Executive Director's Recommendation

Commission Meeting: October 1, 2020

PROJECT Federal Reserve Board Building Project The Federal Reserve 1951 Constitution Avenue, NW Washington, DC	NCPC FILE NUMBER 8113
	NCPC MAP FILE NUMBER 1.34(38.00)45007
SUBMITTED BY Board of Governors of the Federal Reserve System	APPLICANT'S REQUEST Approval of preliminary site and building plans
REVIEW AUTHORITY Federal Projects in the District per 40 U.S.C. § 8722(b)(1) and (d)	PROPOSED ACTION Approval of preliminary site and building plans
	ACTION ITEM TYPE Staff Presentation

Marriner S. Eccles and Federal Reserve Board-East Building Renovation and Expansion

PROPOSED LANDSCAPE PLAN

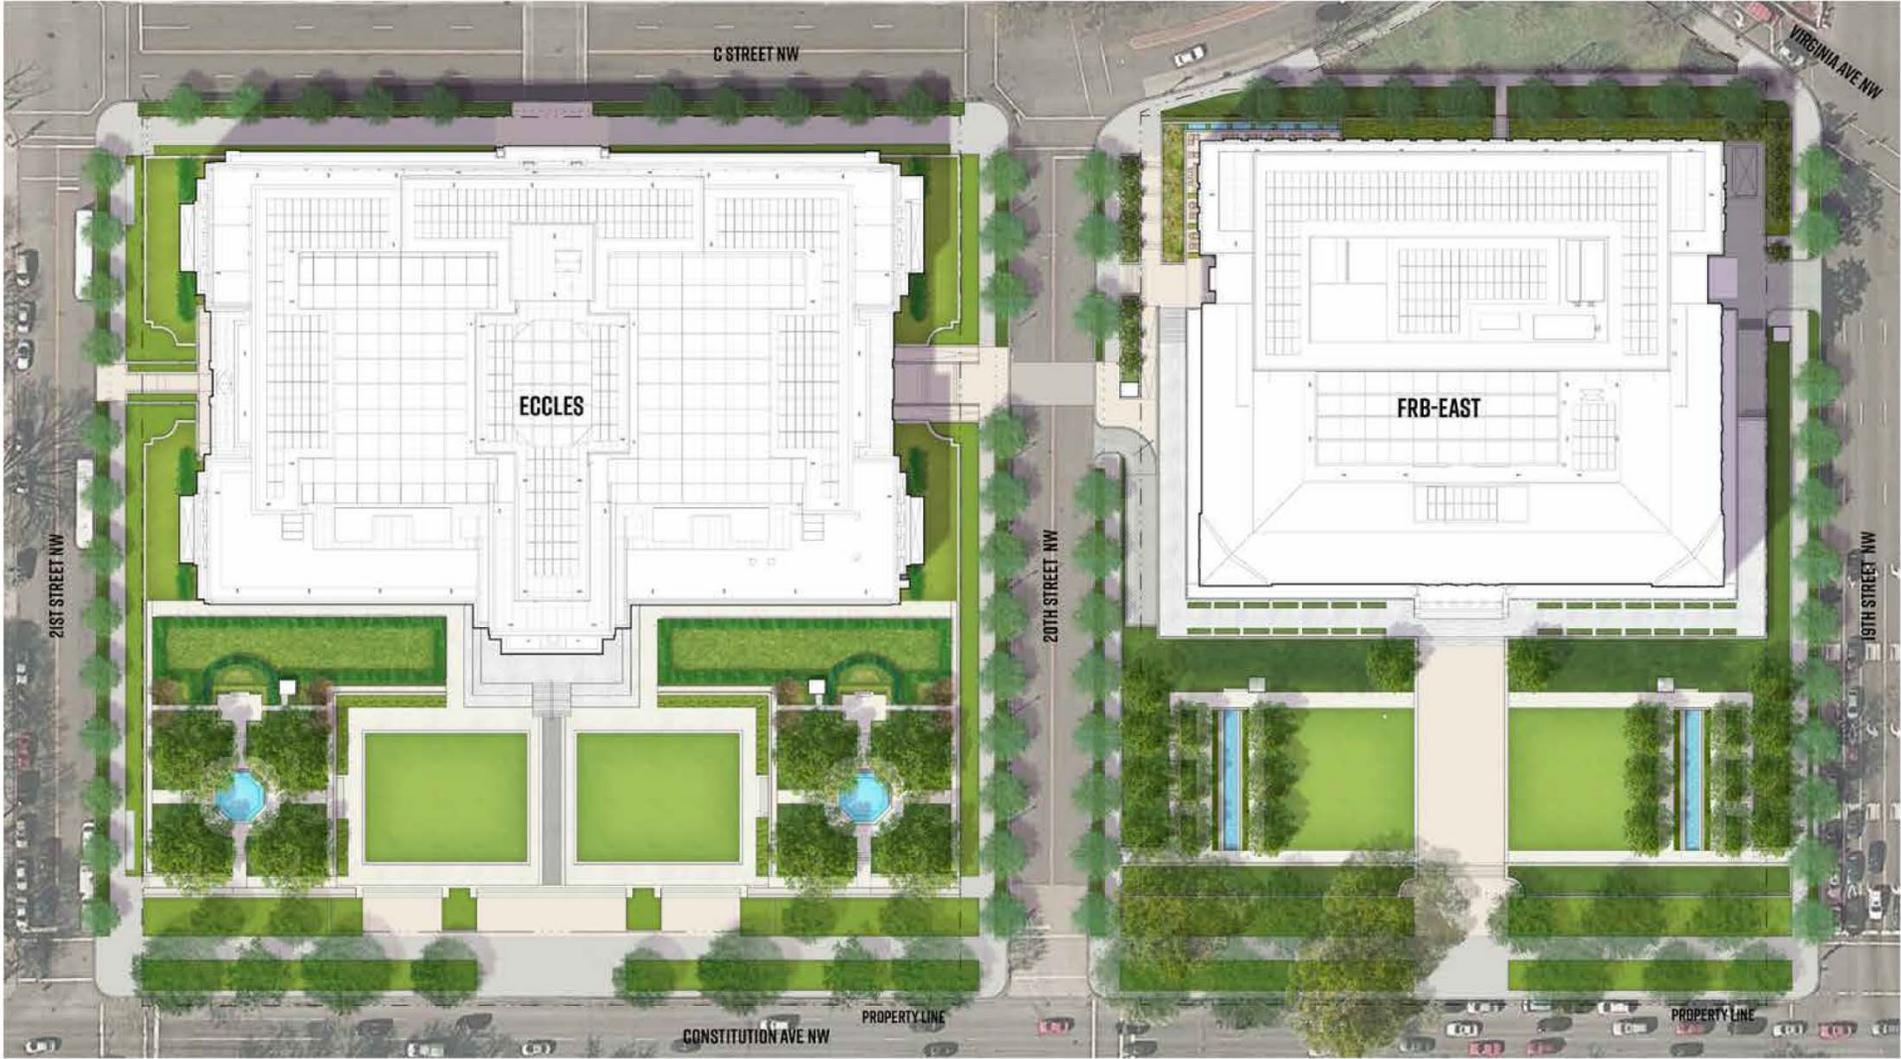
Notes additional refinements to the proposed landscape plan may occur during the 106 process to further minimize the loss or alteration of historic and character-defining landscape features.

Request the Board submit a tree re-planting plan, including size, type, and location, in accordance with NCPC's Tree Replacement Policy.

PROPOSED POST-AND-RAIL VEHICULAR BARRIER

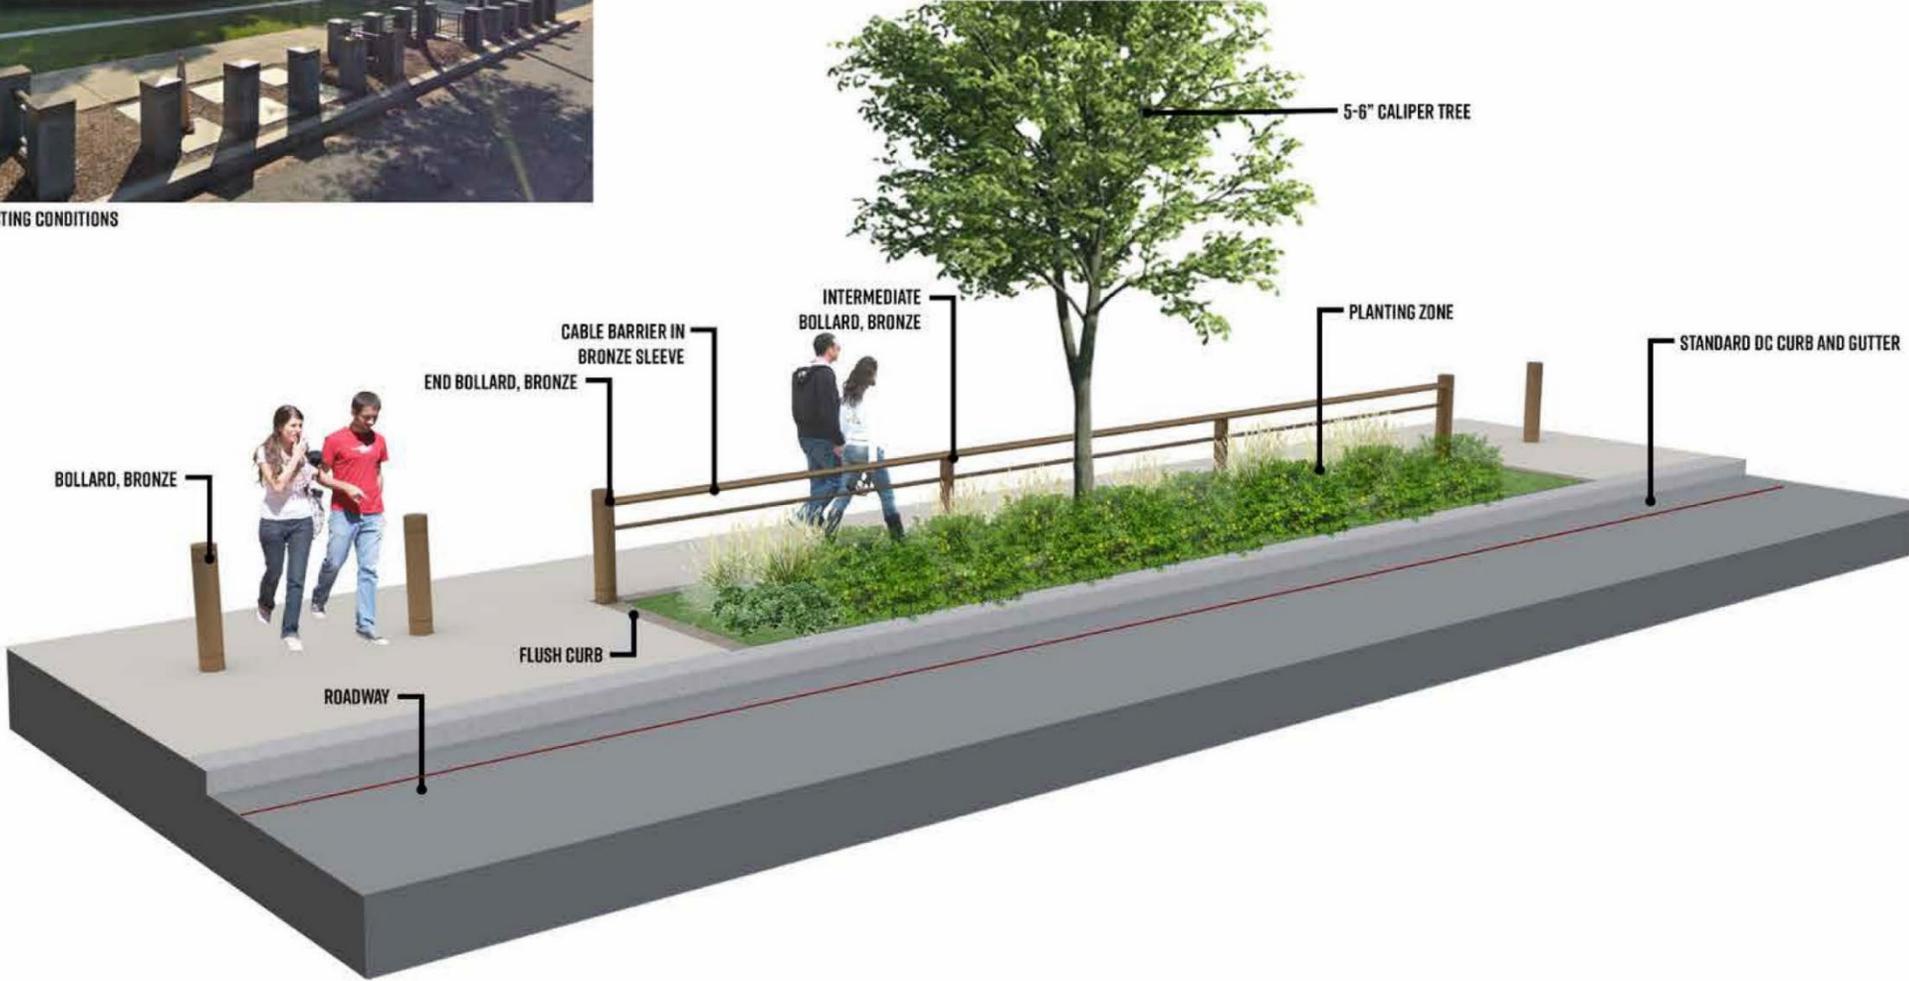
Finds the Board proposes to replace the existing perimeter security system around the Eccles Building with a simpler/more elegant post and rail design in the same location as the existing bollard system.

PROPOSED FRB BUILDINGS | PARKING RAMP PREFERRED SCHEME - LEVEL G1

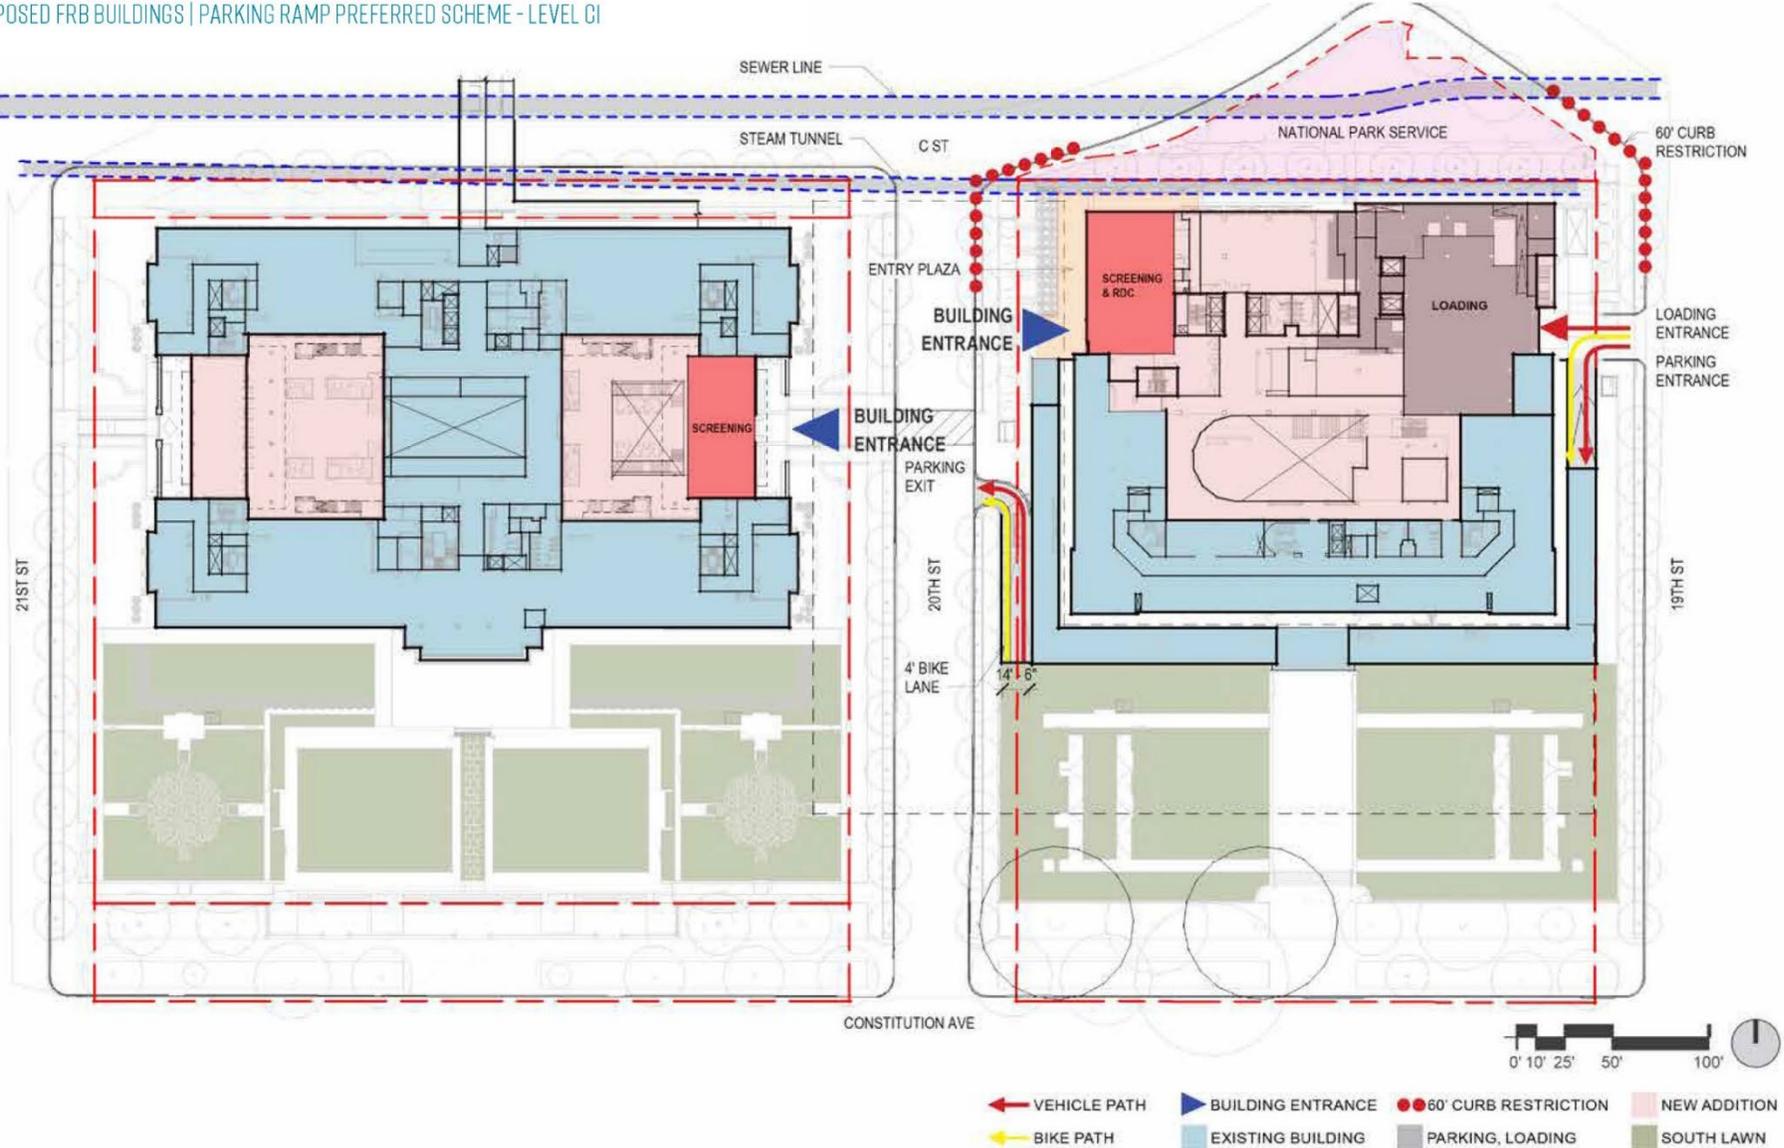
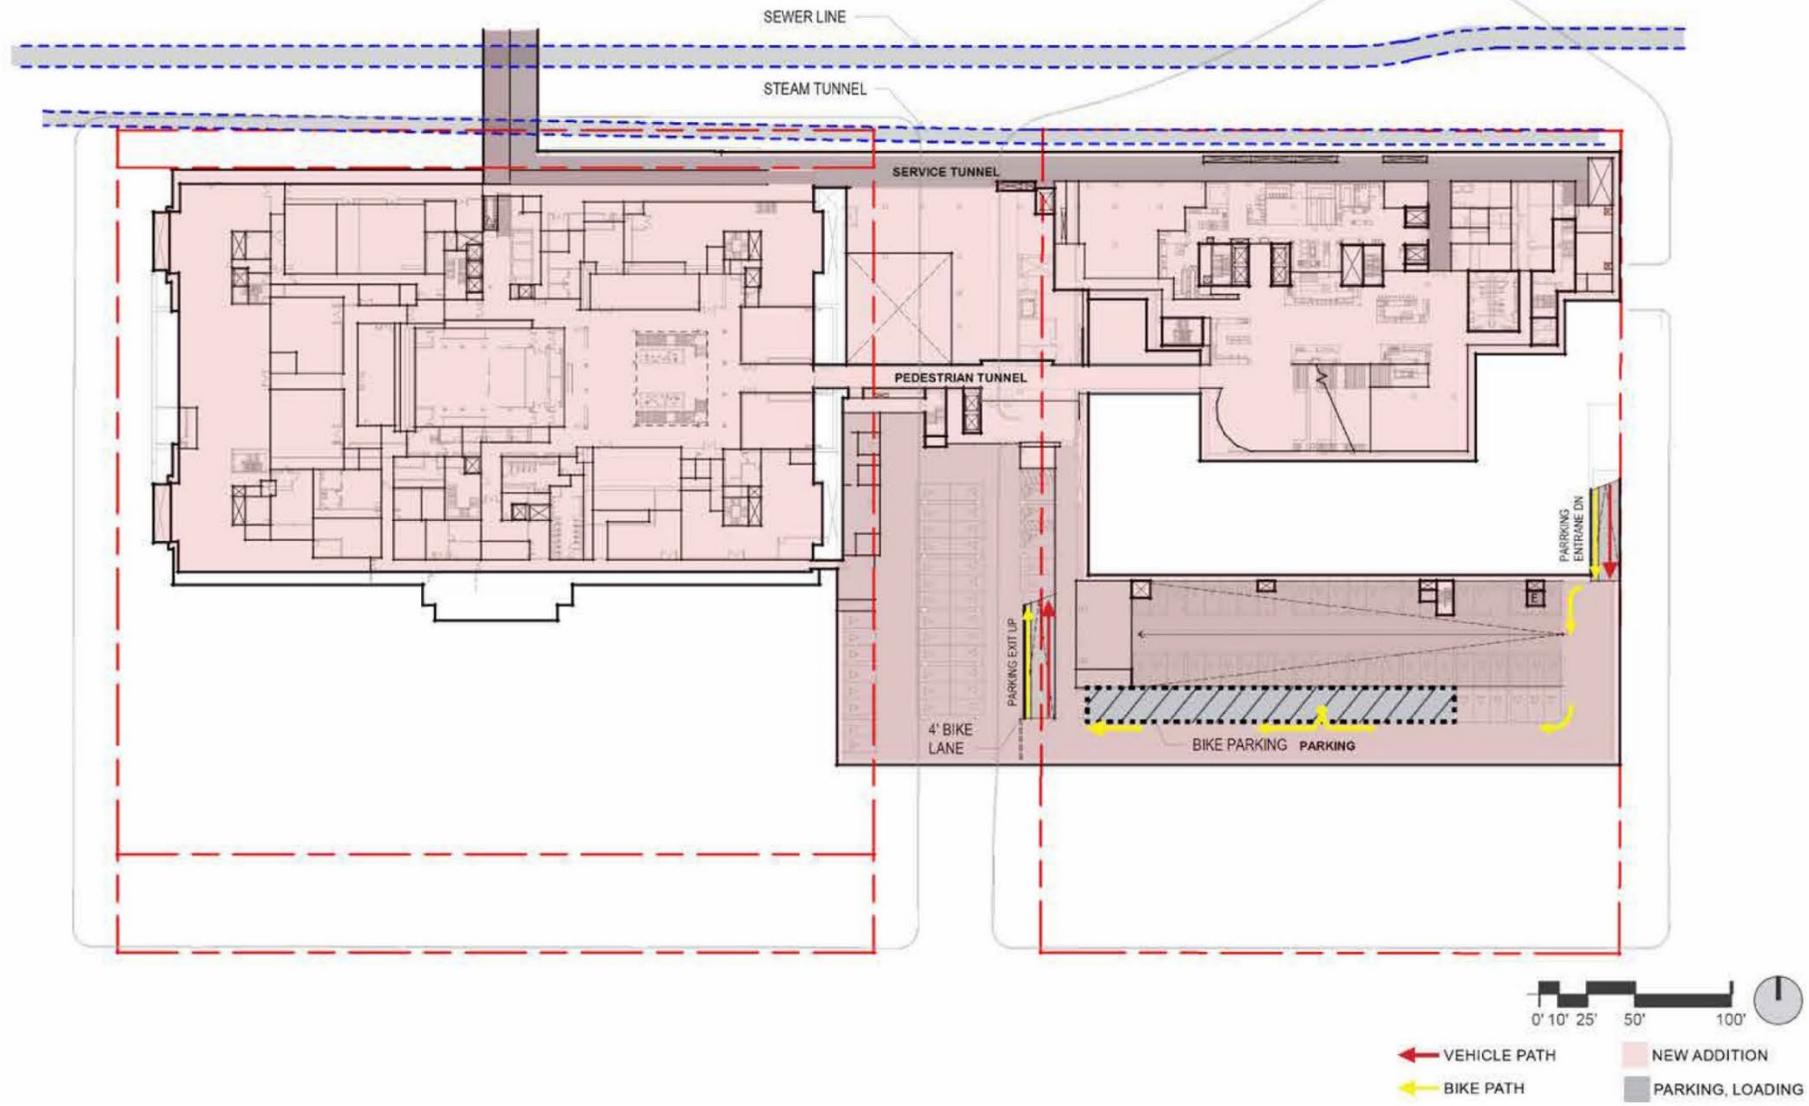
Finds the proposed location of the entry ramp on 19th Street and the exit ramp on 20th Street results in the least amount of impact to the historic building by not altering the building and front lawn's appearance from Constitution Avenue; however there are still outstanding issues with regard to the location of curb cuts and ramps that need to be resolved with the District.

Recommends the Board soften the hard edge of the wall between the sidewalk and the ramp with a landscape buffer.
